**SECTION 00 91 13.01**  
**ADDENDA #01**

- A. Project Name: Royal C. Johnson Veterans Memorial Medical Center New Front Lobby & Primary Care Addition.
- B. Owner: U.S. Department of Veterans Affairs.
- C. Owner Project Number: 438-480
- D. Architect: Stone Group Architects.
- E. Architect Project Number: 201909.
- F. Date of Addendum: February 13, 2024.

Drawing Number  
**C300**

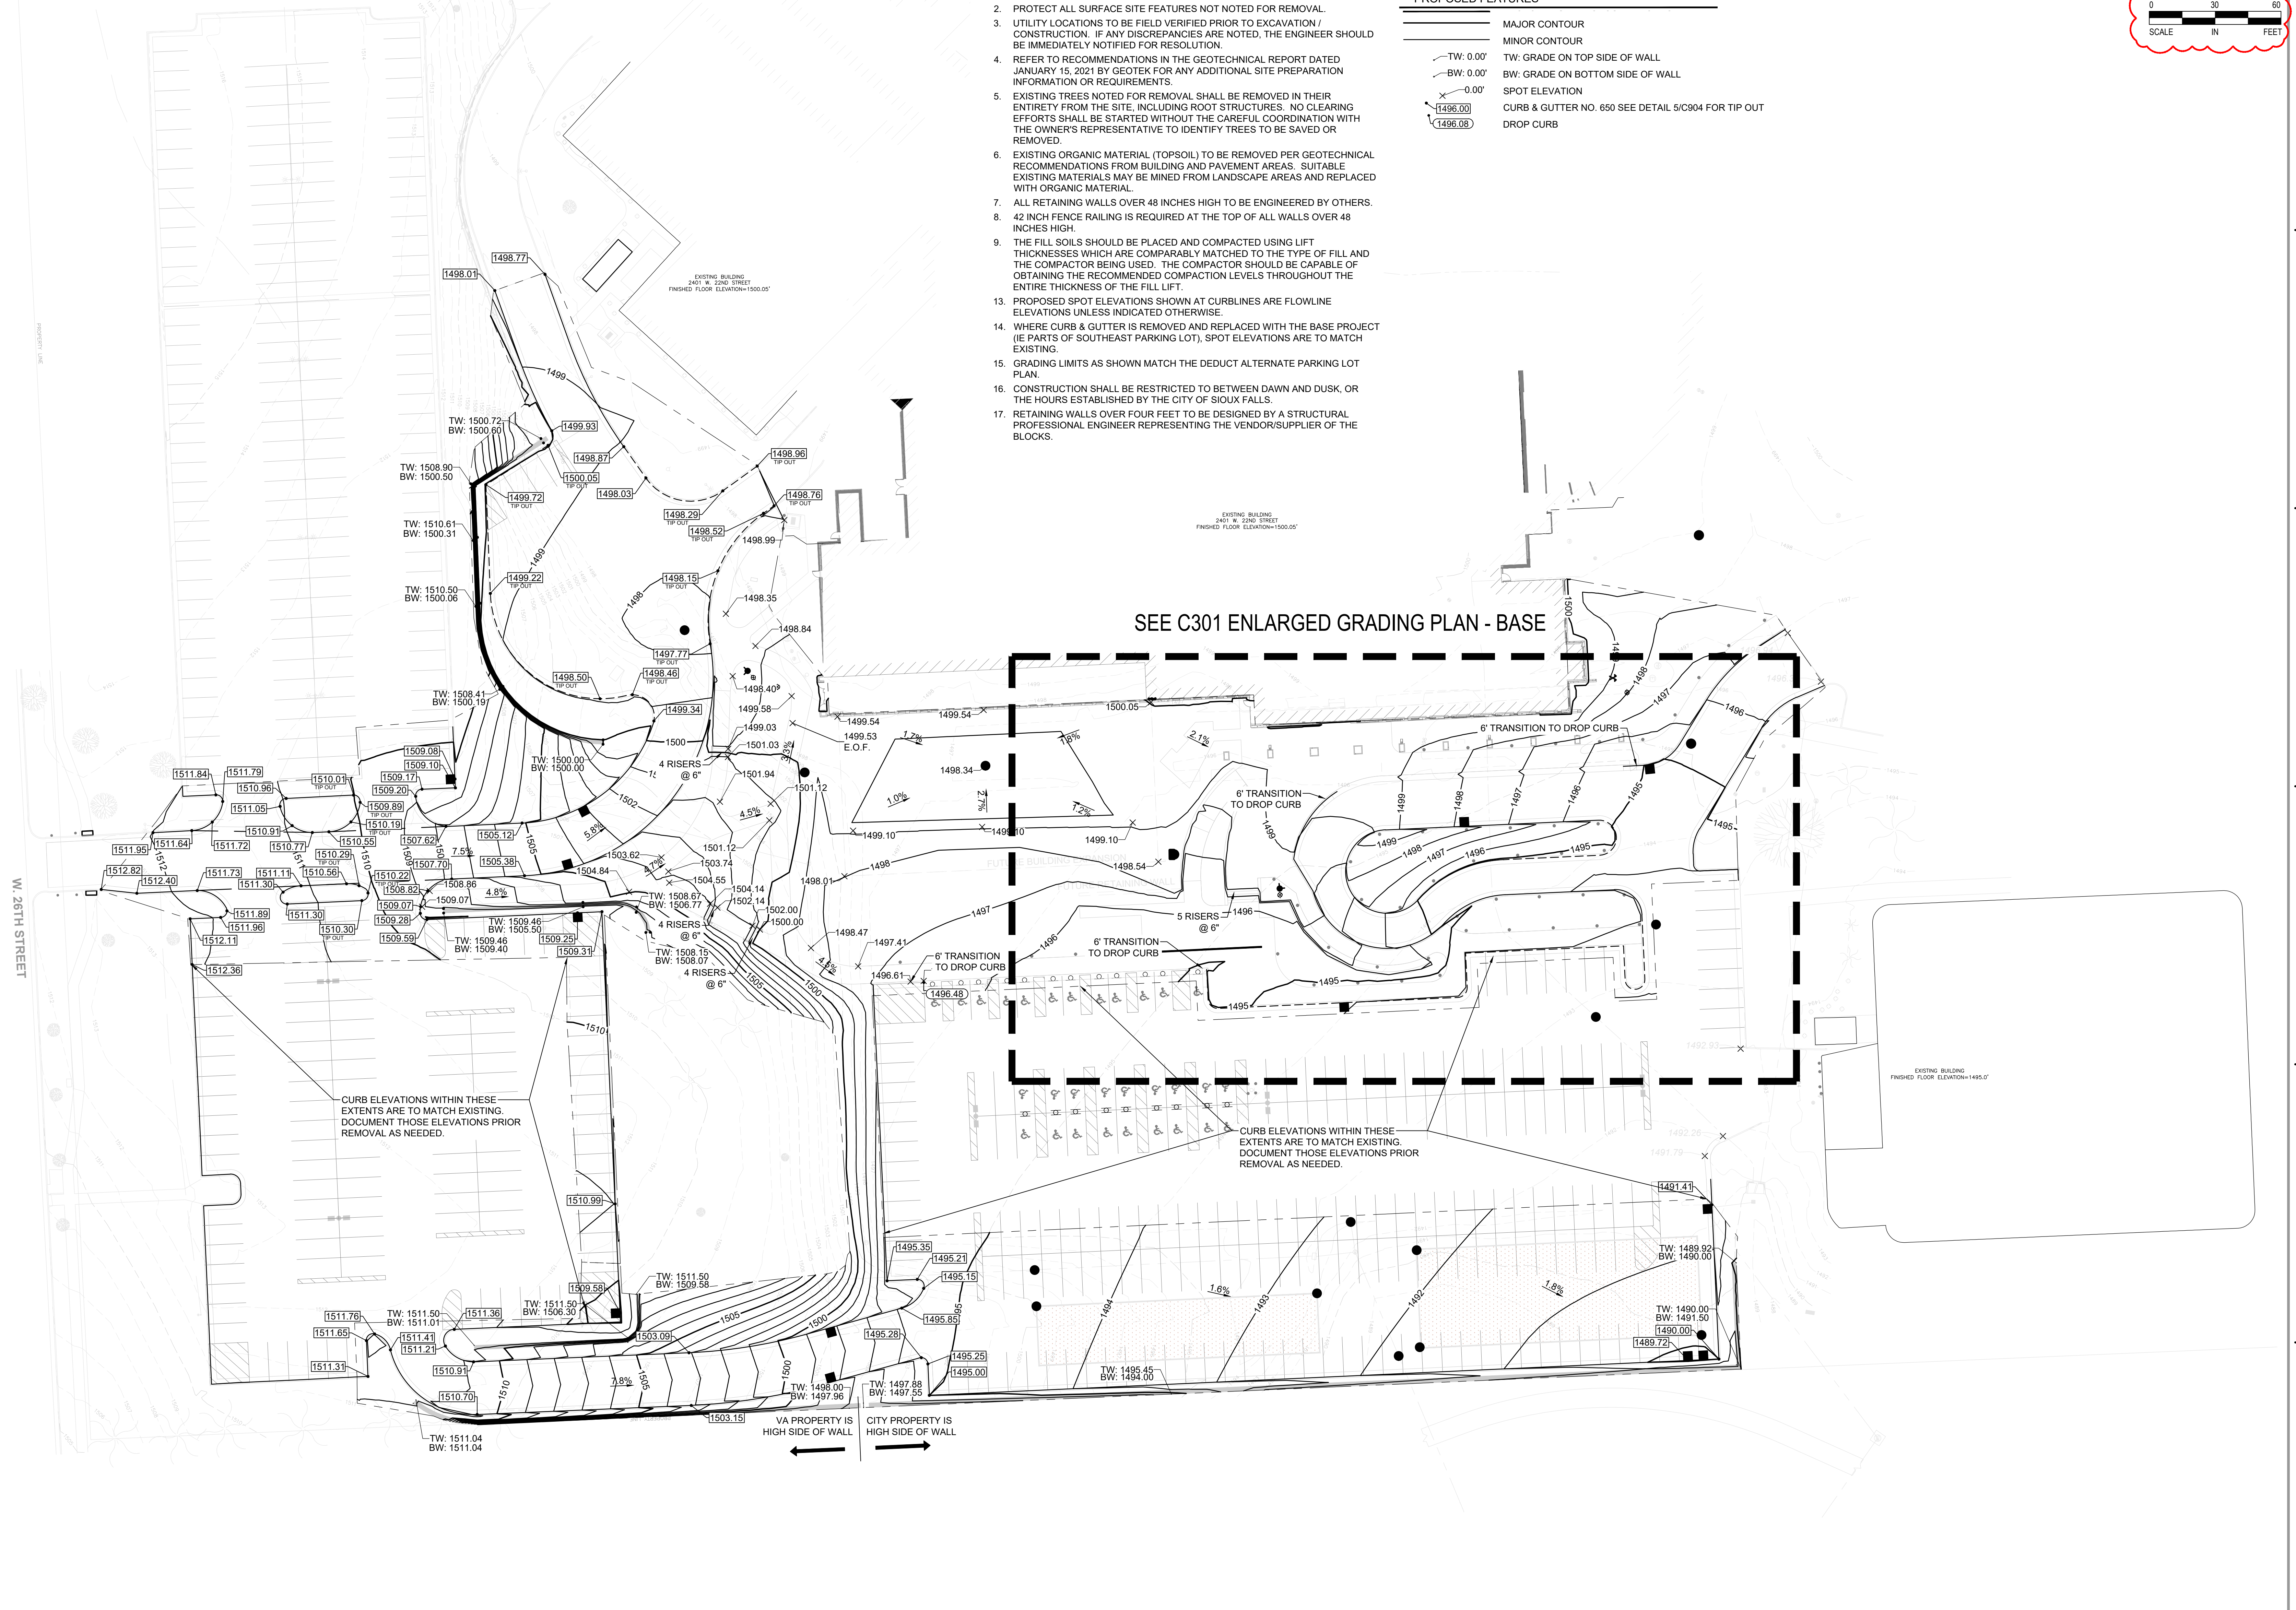
- A. Sheet V001 - TOPOGRAPHIC SURVEY (reissued).
  - 1. Drawing scale revised.
- B. Sheet C101 - DEMOLITION PLAN - DEDUCT ALTERNATE (reissued).
  - 1. Drawing scale revised.
- C. Sheet C200 - SITE PAVING PLAN BASE (not reissued).
  - 1. Callout note for ADA parking signage should read "ALL PARKING SIGNS TO BE MOUNTED ON BOLLARDS - SEE DETAIL 1/C905 FOR REQUIRED DIMENSIONS AND DETAIL 2/C905 FOR BOLLARD MOUNTING TYPE."
- D. Sheet C210 - CONCRETE JOINTING PLAN BASE (reissued).
  - 1. Drawing scale revised.
- E. Sheet C300 - GRADING PLAN - BASE (reissued).
  - 1. Drawing scale revised.
- F. Sheet C301 - ENLARGED GRADING PLAN - BASE (reissued).
  - 1. Drawing scale revised.

Drawing Number  
AE313

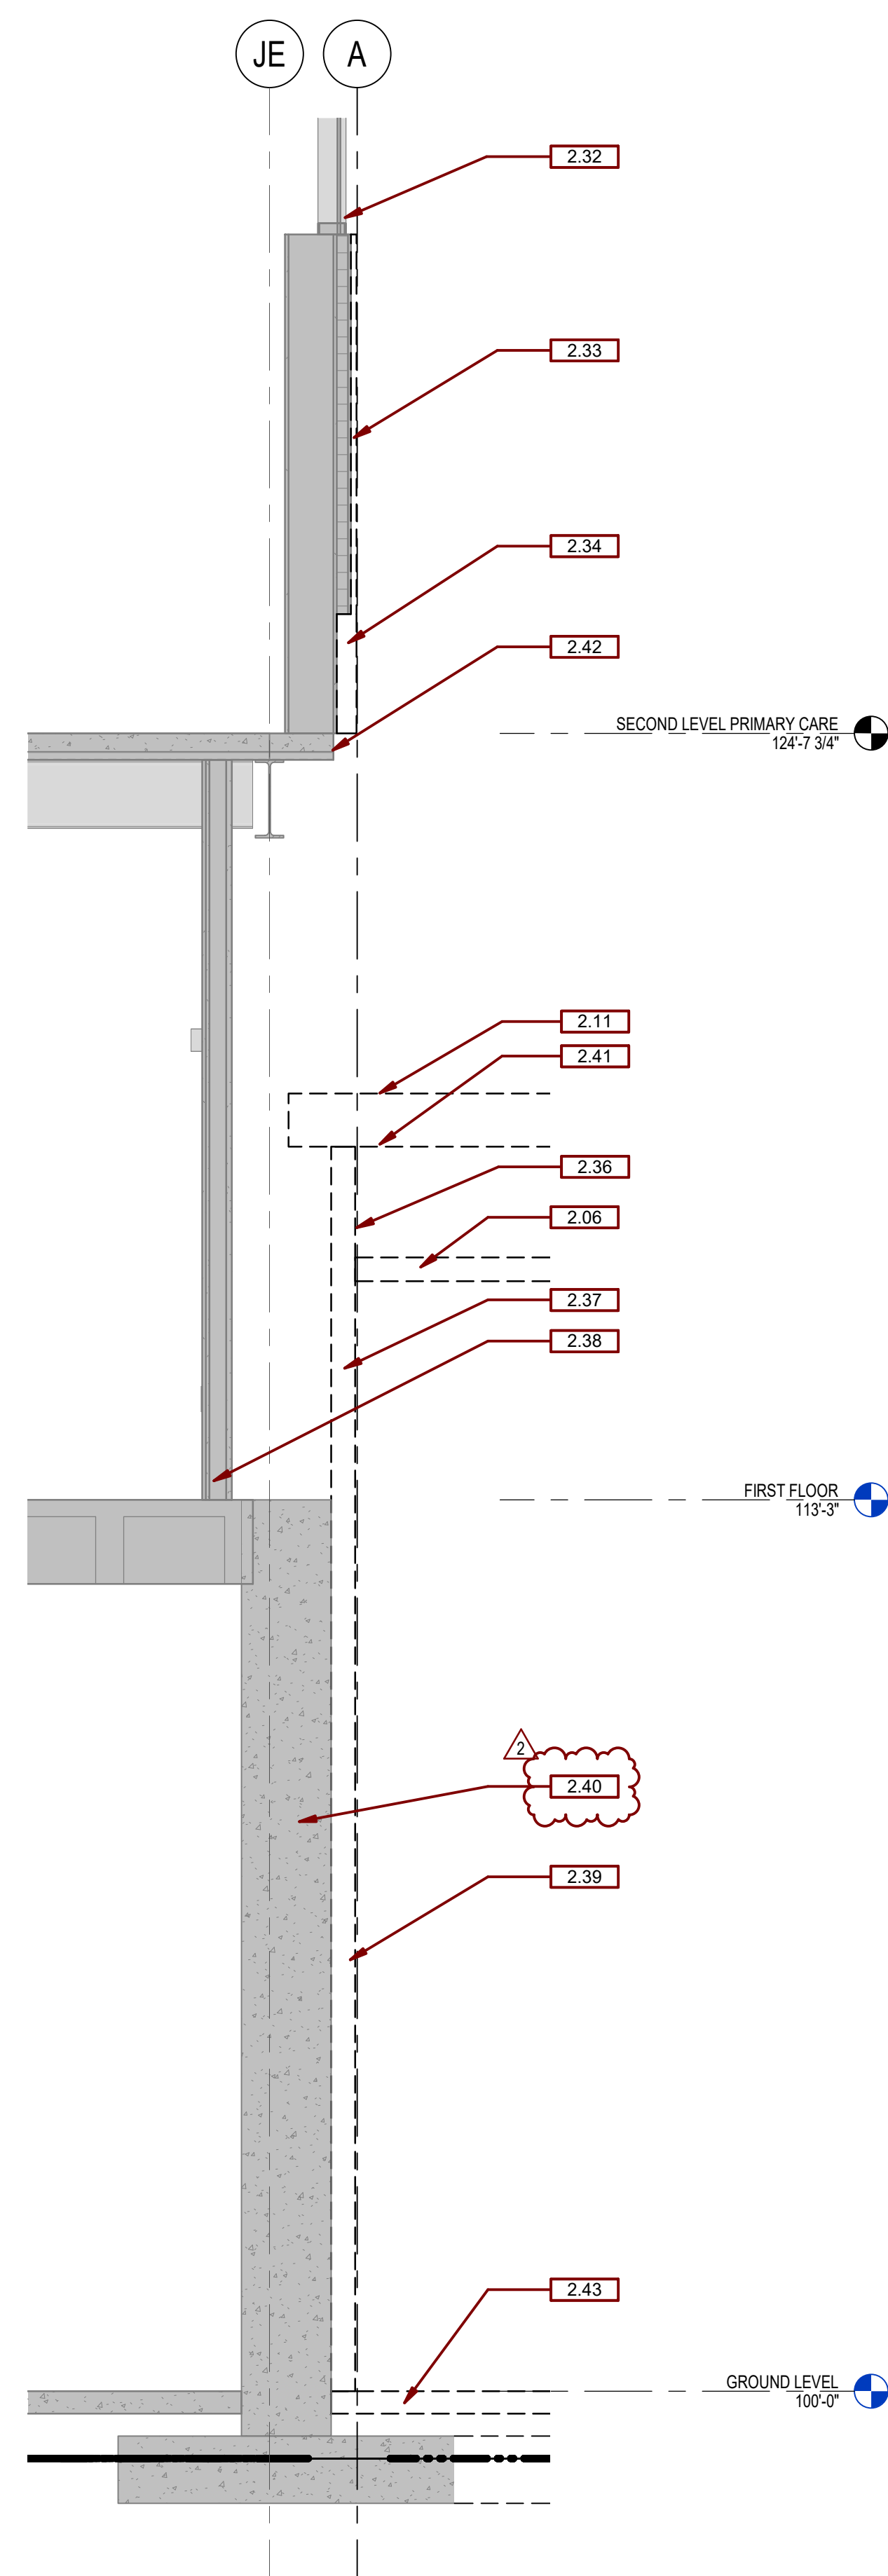
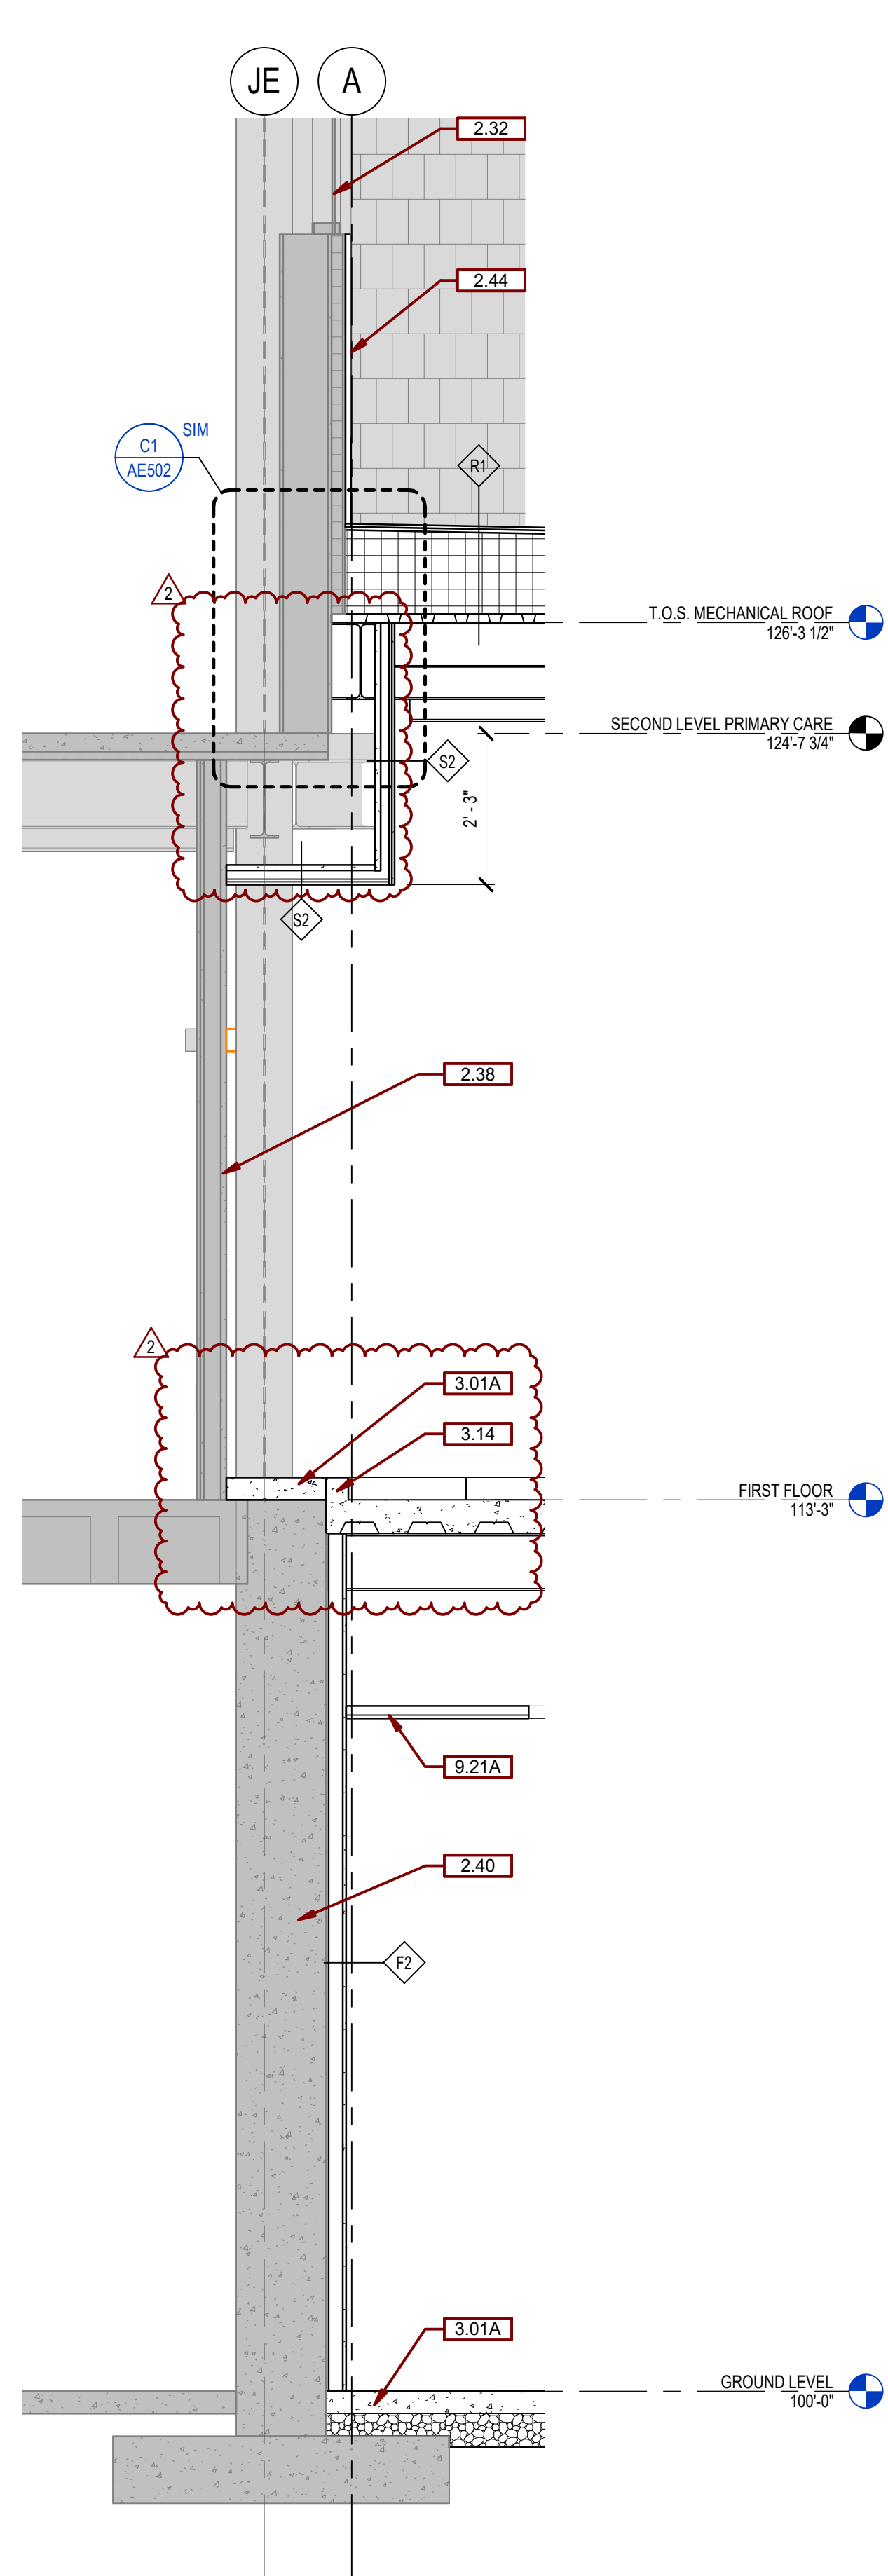
- N. Sheet AE313 - WALL SECTIONS (reissued).
  - 1. Section F1 - added "similar" clarification to roof type designation.
  - 2. Detail B4 - Revisions and clarifications to detail.
  - 3. Detail B6 - Revisions and clarifications to detail.

**E1A WALL SECTION AT CONNECTION TO EXISTING - DEMOLITION A**  
1/2" = 1'-0"

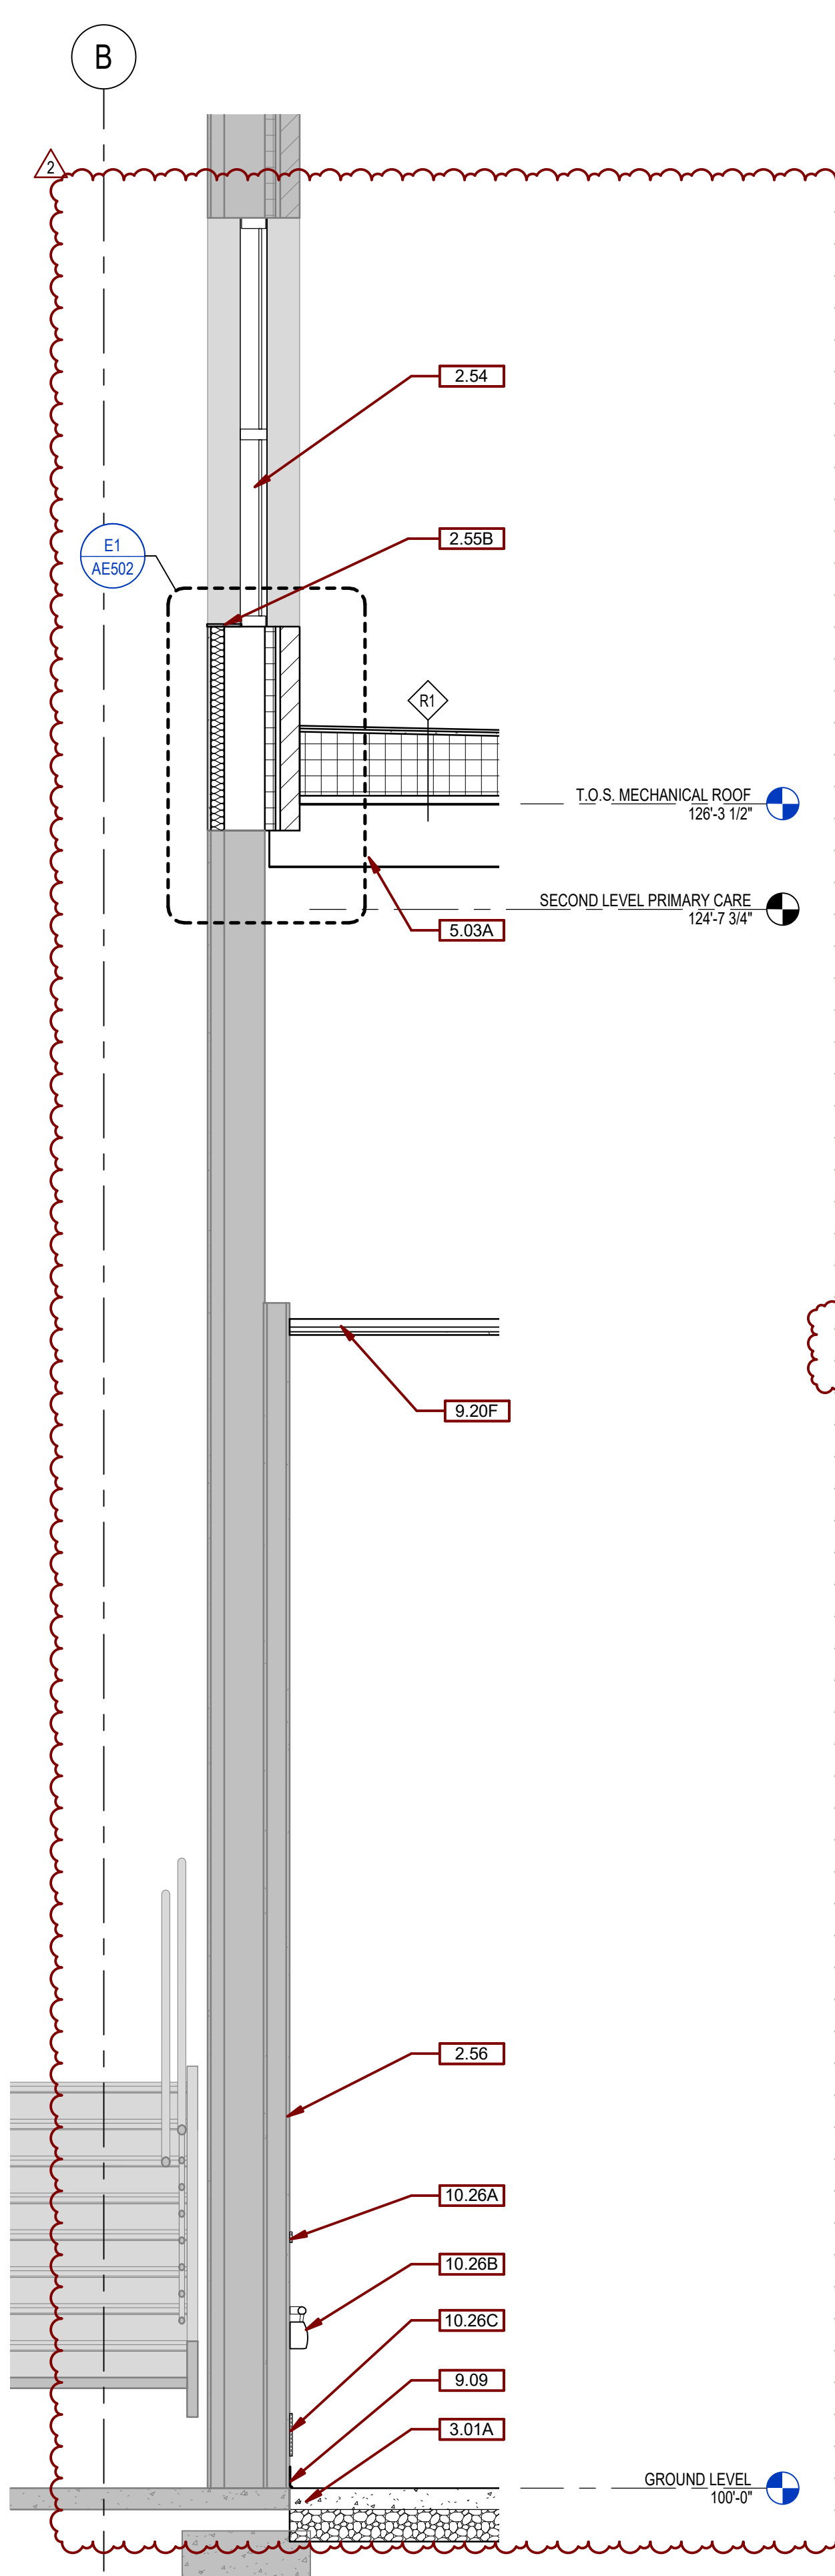
- O. Sheet AE314 - WALL SECTIONS (reissued).
  - 1. Section E1A - Added keynote for existing concrete wall to remain.
  - 2. Section E1B - Added clarification to new floor slab and removed insulation hatch in shaft wall assembly.
  - 3. Section E2A - Added keynote for existing beams to be removed.
  - 4. Section E2B - Removed insulation hatch in shaft wall assembly.
  - 5. Keynotes - Revised keynote 2.35.
